SERVICE BULLETIN RELEASE - 09/26/2014

09-042/14 – 2014 -2015 MAZDA3 - WHITE FELT VISIBLE FROM FRONT DOOR TRIM JOINT CAUSING POOR APPEARANCE

Subject: WHITE FELT VISIBLE FROM FRONT DOOR TRIM JOINT CAUSING POOR APPEARANCE	Bulletin No: 09-042/14
	Last Issued: 09/26/2014

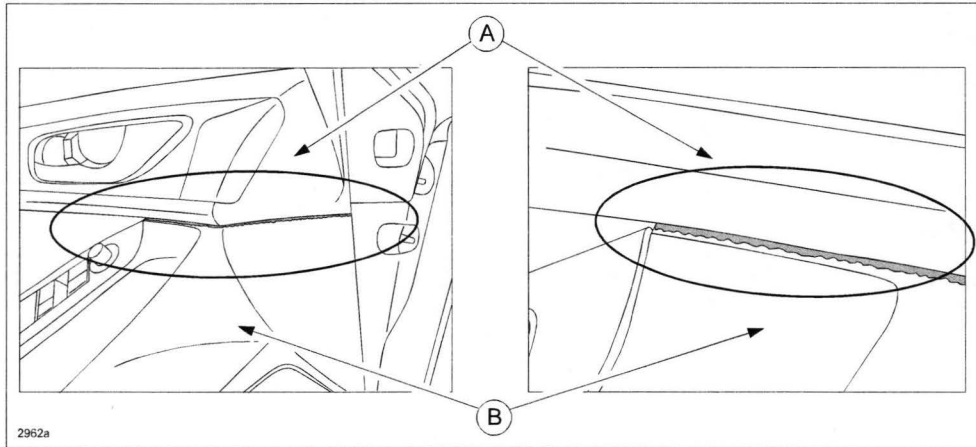
Some vehicles may exhibit a white felt (used for noise insulation) visible through the gap between the upper (A) and lower (B) front door trim, causing a poor appearance.

The cause of this is that the color of the felt and the glue is not appropriate and highly visible. To correct the problem, the color of the felt and the glue has been changed to one that resembles the door trim. The production control and the inspection have also been improved to eliminate the protruding felt.

1. Verify customer concern.
2. Replace the concerned front door trim with a modified one according to the instructions on MS3 online or the Workshop Manual (section 09-17 FRONT DOOR TRIM REMOVAL/INSTALLATION).
3. Verify repair.
